Addendum No. 1
Rock River Water Reclamation District
Plant Roadway Improvements 2020
Capital Project No. 2106

This Addendum No. 1, dated August 13, 2020, for the above referenced project, supersedes all contrary and conflicting information in the specifications and contract documents, which are hereby supplemented or revised as follows:

PLANT ROADWAY IMPROVEMENTS 2020 CAPITAL PROJECT #2106

TYPICAL SECTIONS ALIGNMENT F -1

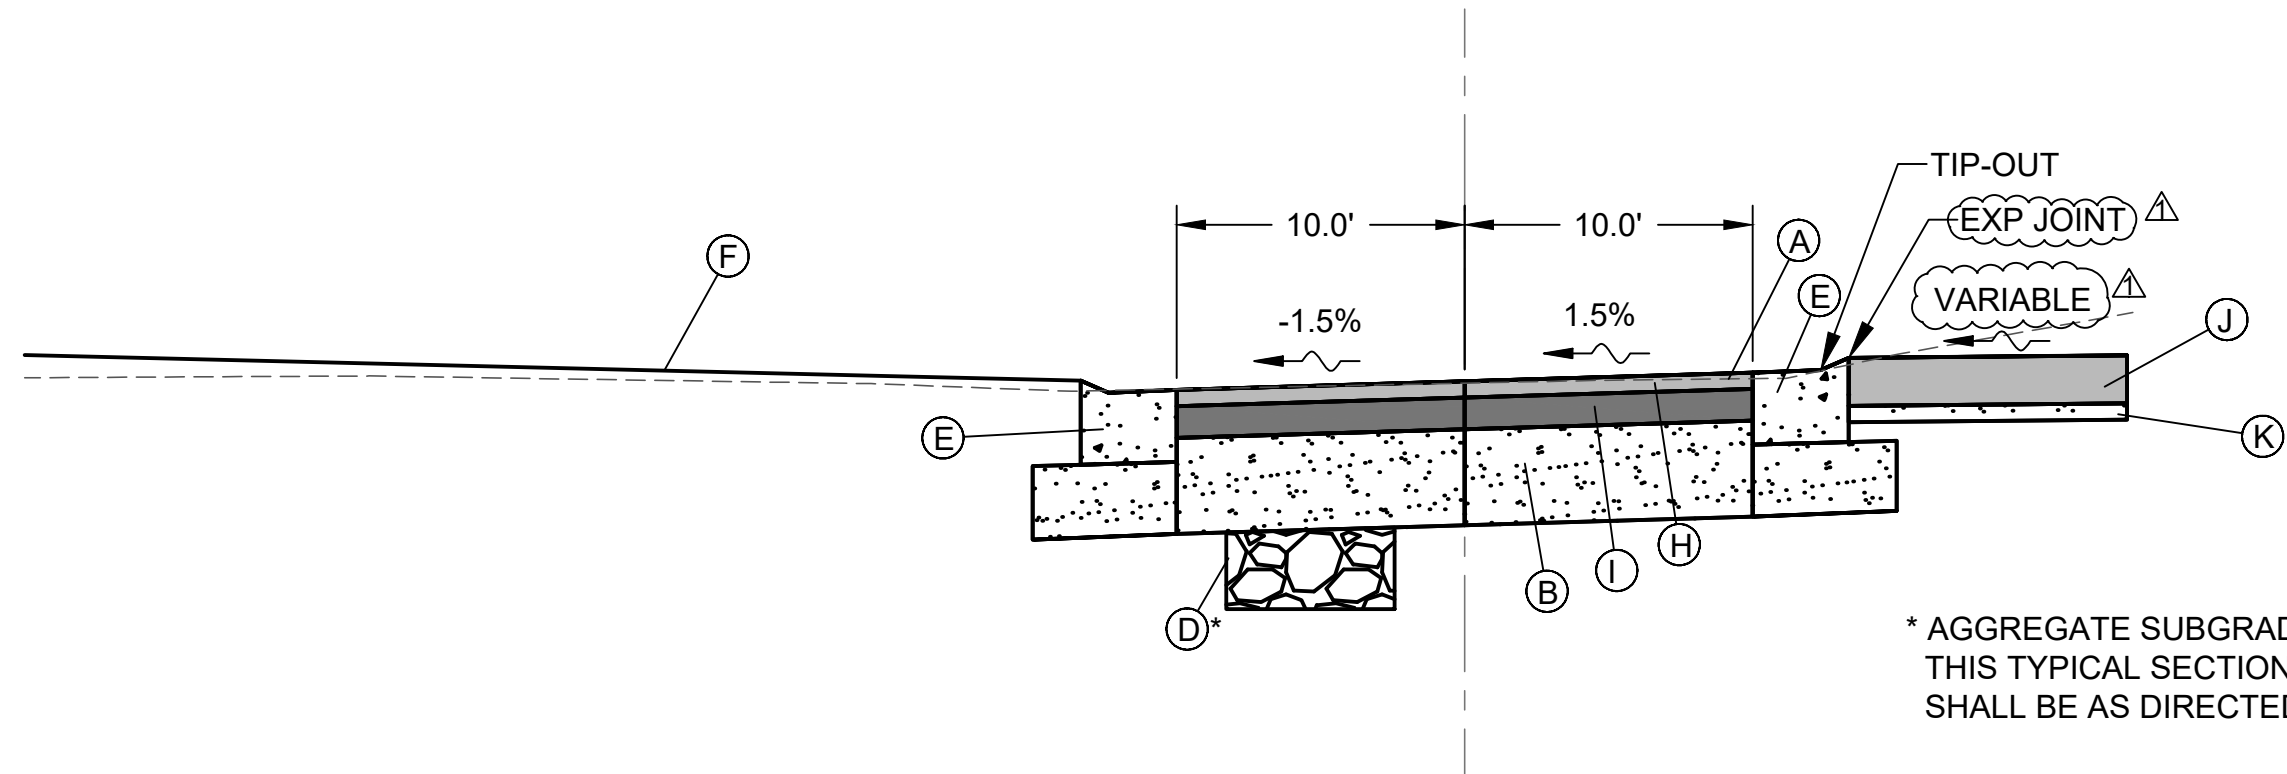
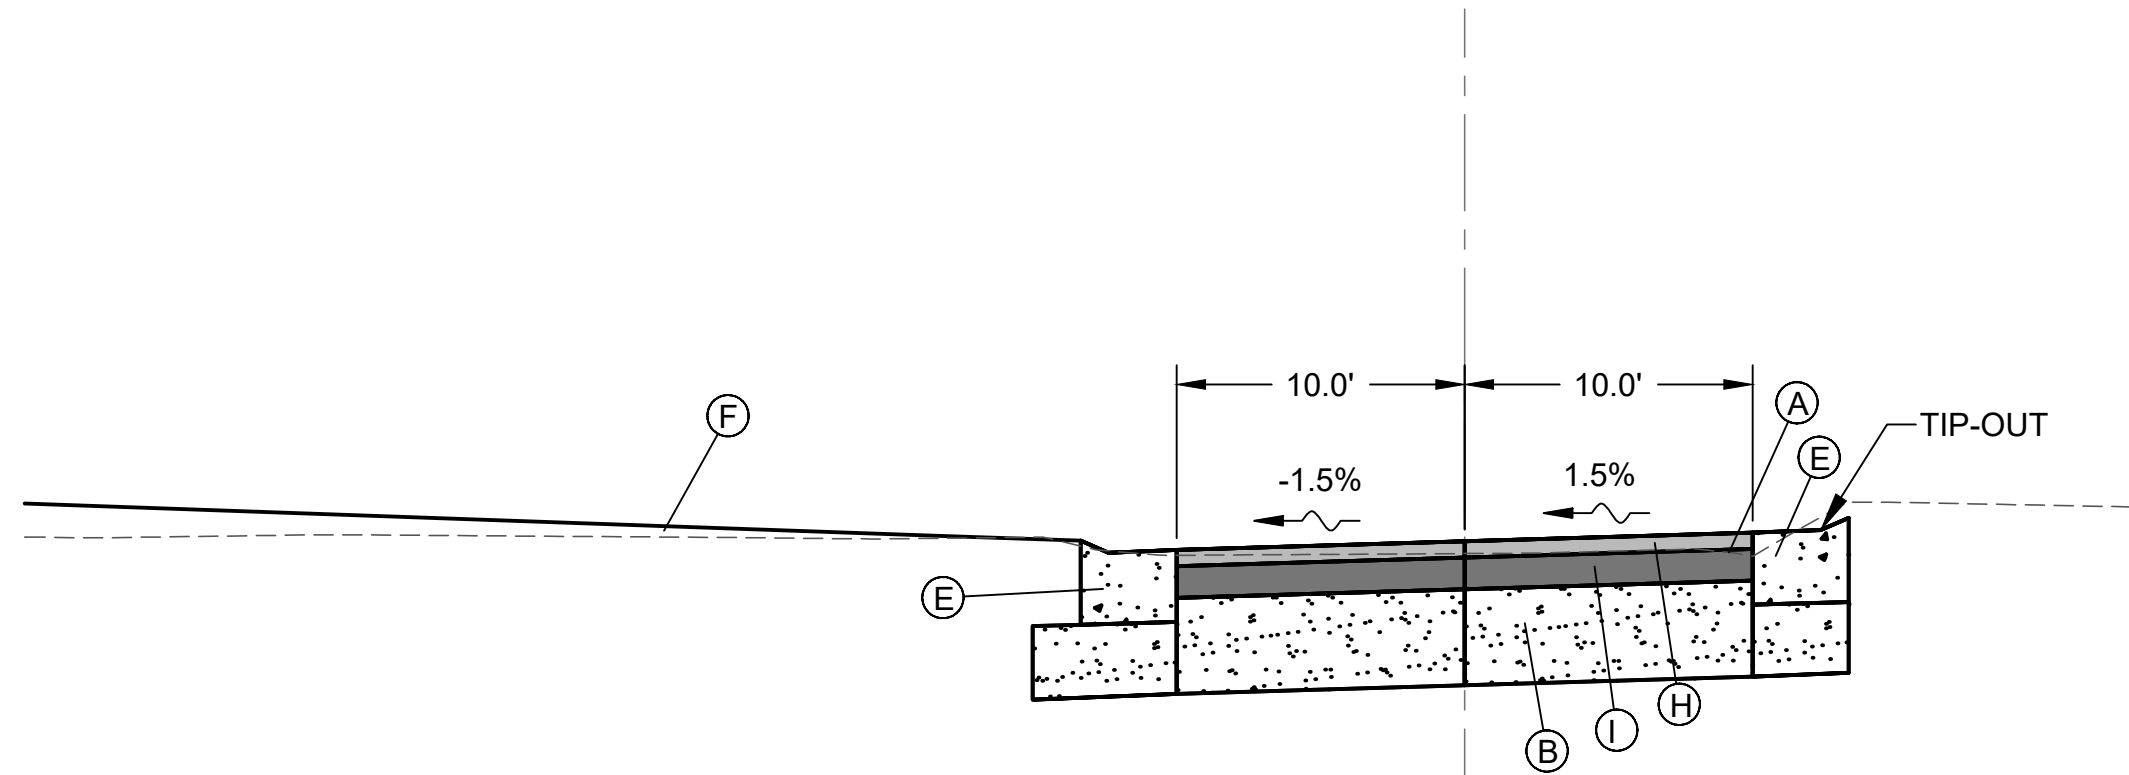
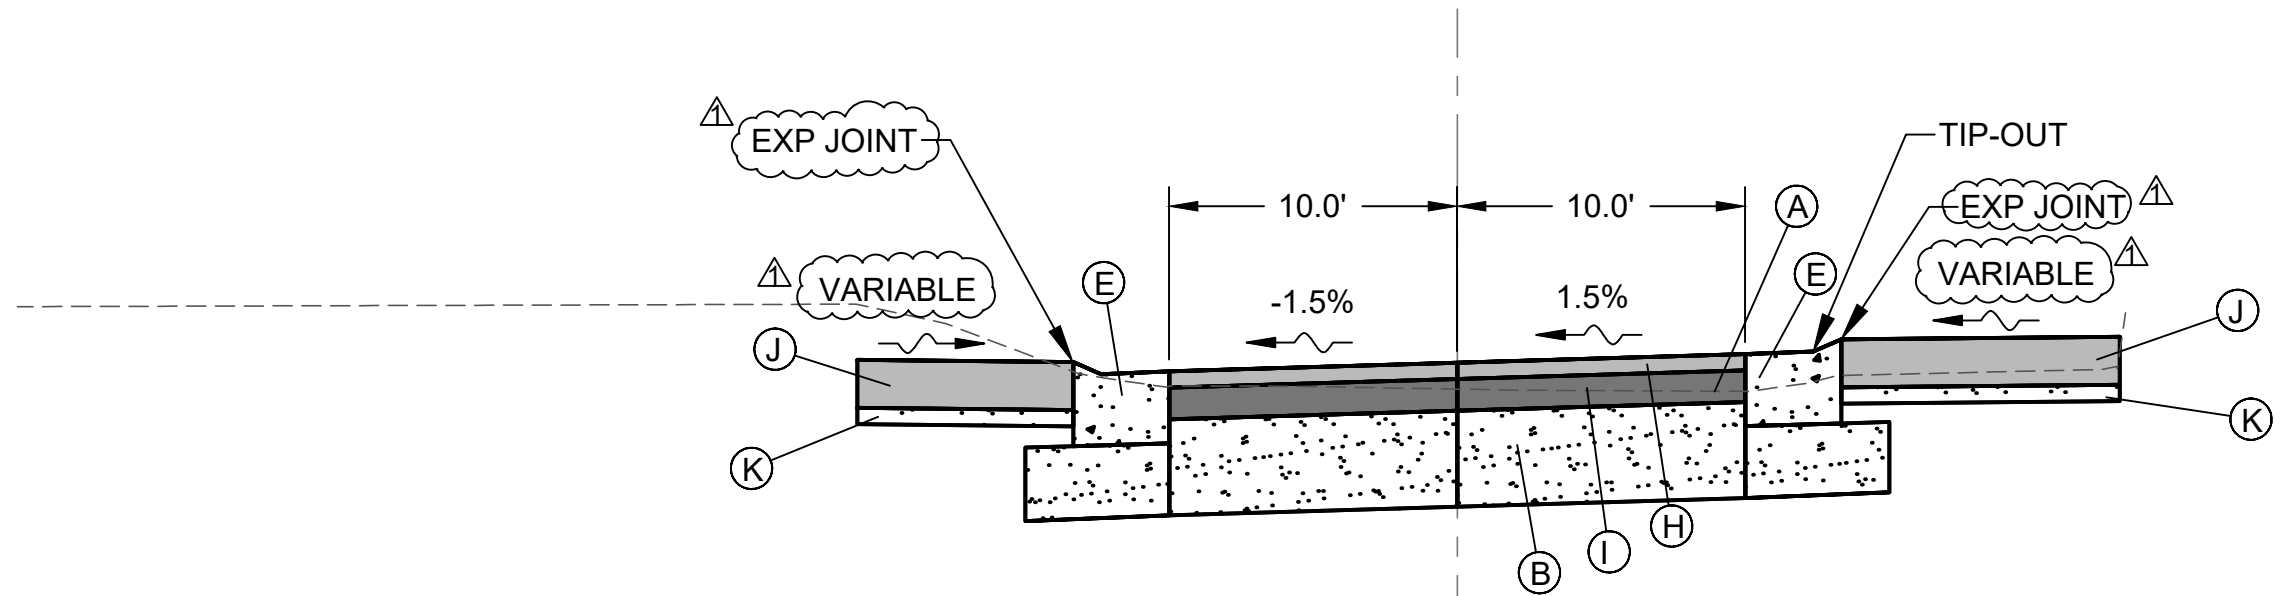
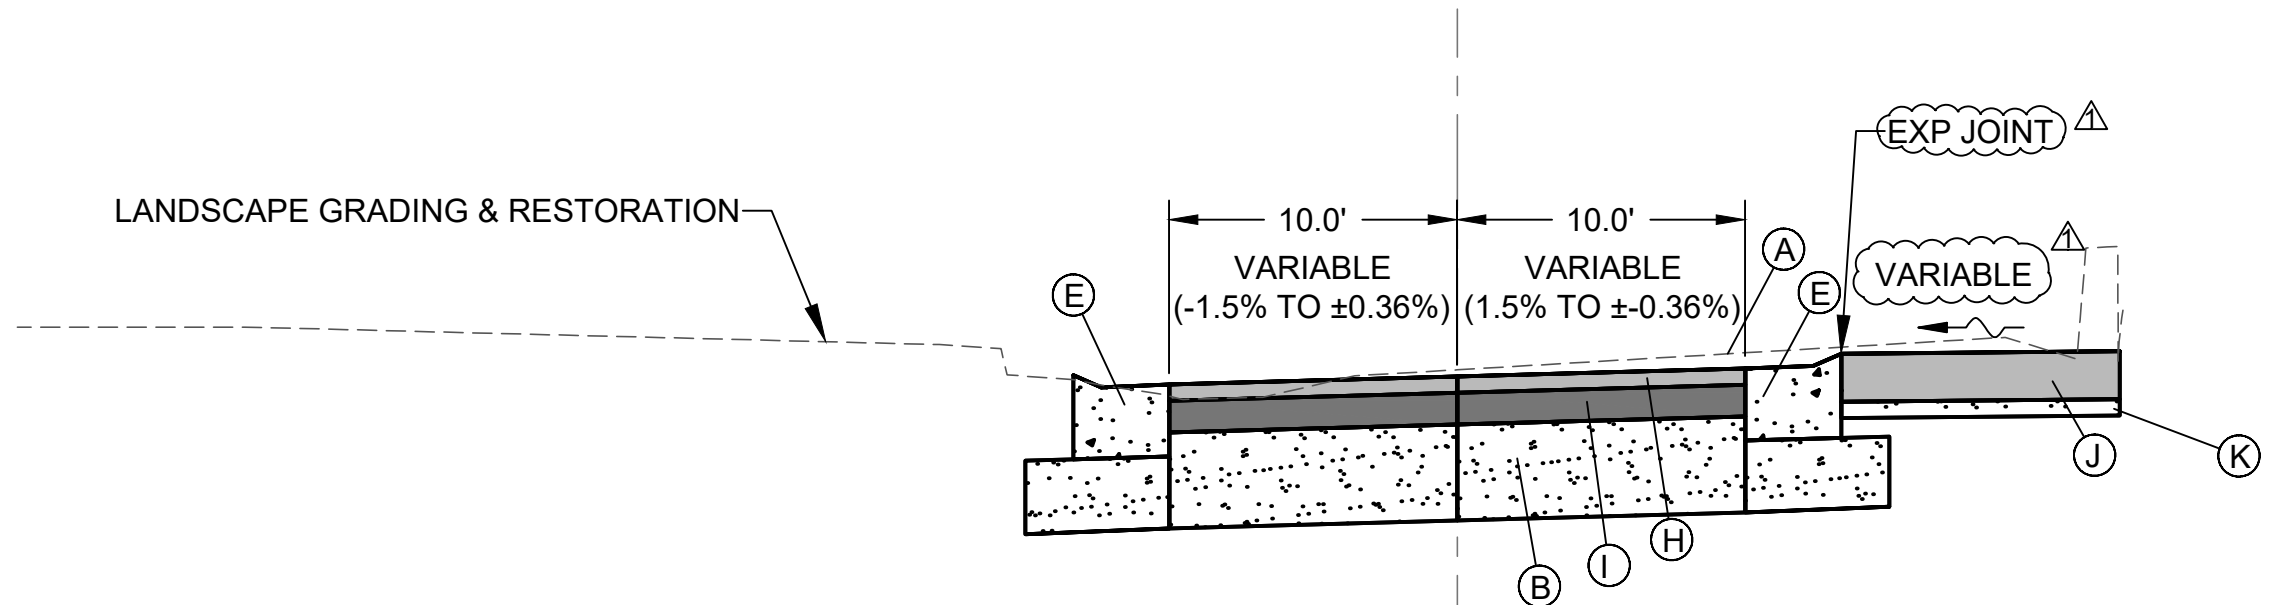
1. Typical Sections have been updated to reflect the addition of expansion joint and to note that the proposed PORTLAND CEMENT CONCRETE SIDEWALK, 6" will have a variable slope.
